CITY OF WEST TORRENS

Notice of Special Panel Meeting

6.1.1 381-385 Anzac Highway, CAMDEN PARK

Application No 211/1097/2019

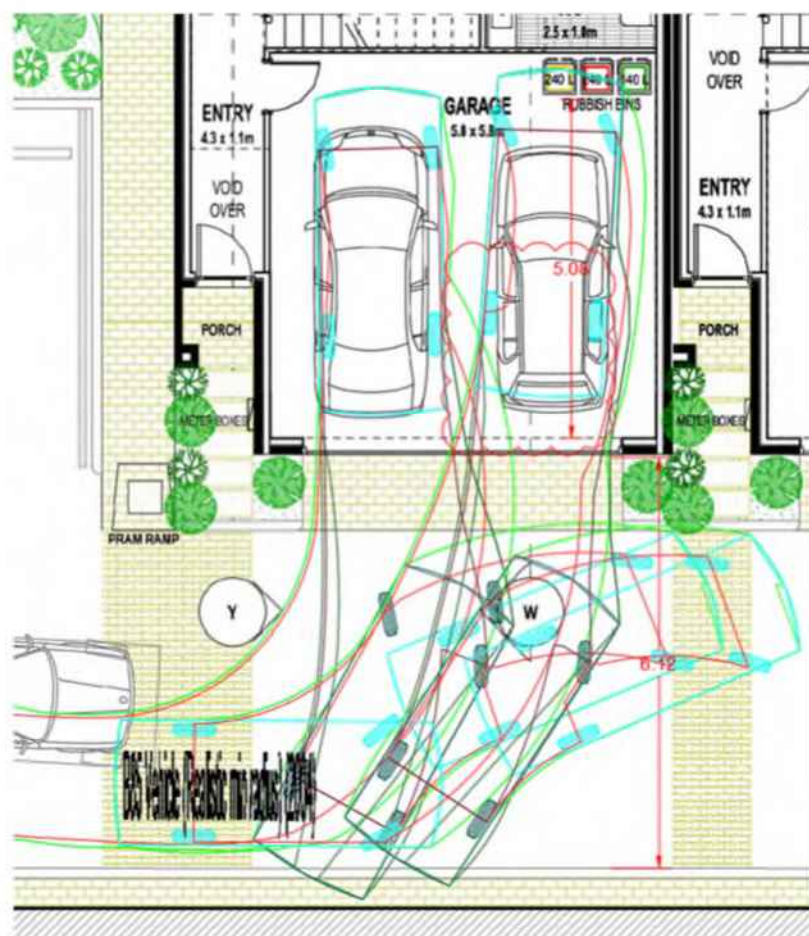
3.2 Further demonstration that this is required for the turning path of a MRV truck should be provided, if the site is to be service by a MRV waste vehicle. Refer to dot point 4.2 for further information.

3.3 Spaces 27 do not comply with AS/NZS 2890.1-2004 as there is no additional 0.3m clearance provided for spaces adjacent to walls.

- 3.4** It is unclear if there is a solid wall proposed alongside the bicycle parking next to parking space 17. If a solid wall is present, drivers exiting the undercroft car park would have no sight lines of the approaching traffic from the driveway of the townhouses, which would be a safety concern.

It is recommended that revised plans indicating satisfaction to the above requirements should be provided to Council.

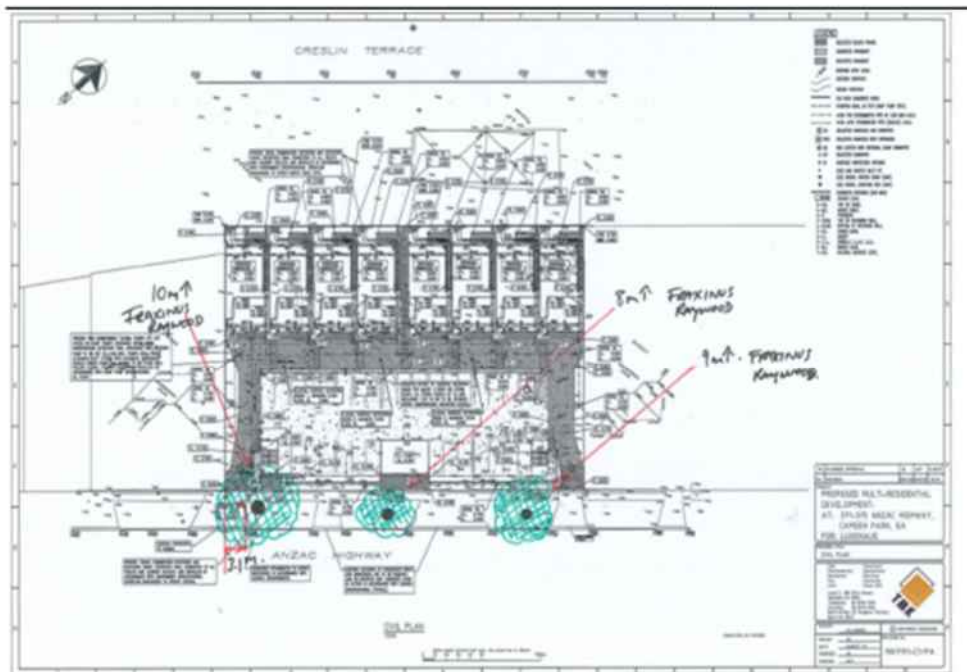
The developer will be required to contact the City Of West Torrens Customer Service Unit prior to the start of construction to arrange the programming of pruning works.

City Operations will not support this development in its current form.
